**National Committee on
Uniform Traffic Control Devices**

**National Committee on Uniform Traffic Control Devices
RWSTC RECOMMENDATION FOLLOWING SPONSOR COMMENTS**

TOPIC: Vertical clearance of Preferential Lane signs and overhead signing for preferential lanes (NPA versus 2009 MUTCD)

AFFECTED PORTIONS OF MUTCD: Section 2G.03 and 2G.06 (2009 MUTCD)

104 **Figure 2G-3. Example of Signing for a General-Purpose Lane that Becomes a**
105 **Continuous-Access Contiguous or Buffer-Separated HOV Lane**

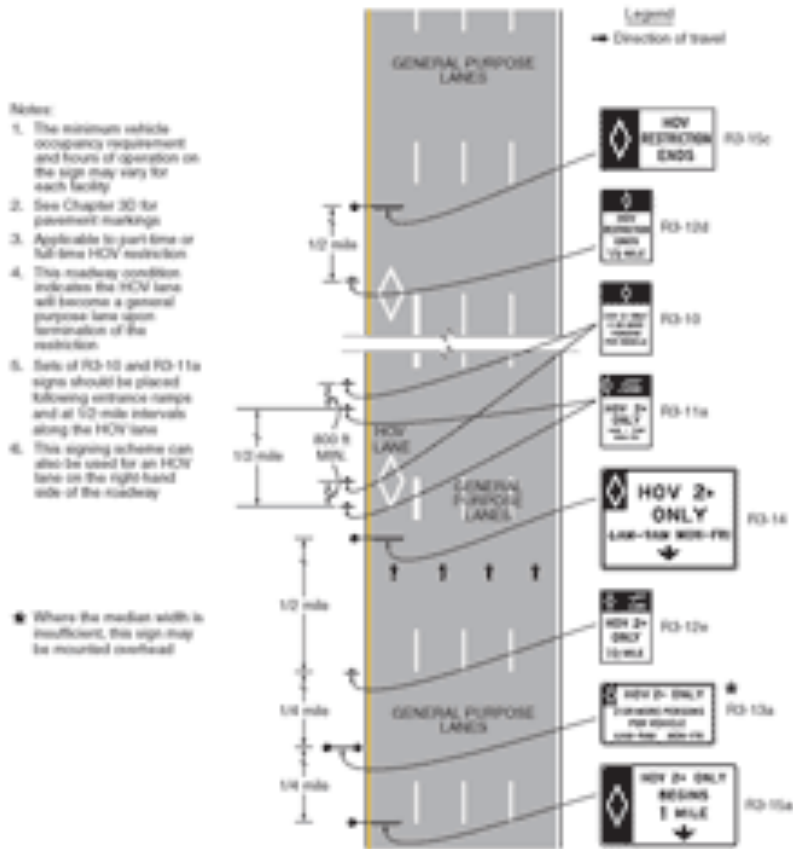
41 Section 2G.06- the NPA had the overhead preferential lane begins (R3-15a) as a **shall**
42 condition where a lane becomes a preferential lane rather than a should condition since
43 this is a mandatory lane for a freeway/expressway application. This is then more
44 consistent with Section 2E.24 for lane drops on freeways/expressways which require
45 overhead signing. However, the overhead sign is a should condition and engineering
46 judgement can be used to determine if the overhead sign is necessary versus a side
47 mounted sign. No change

103 **NO CHANGE RECOMMENDED TO Section 2G.06**
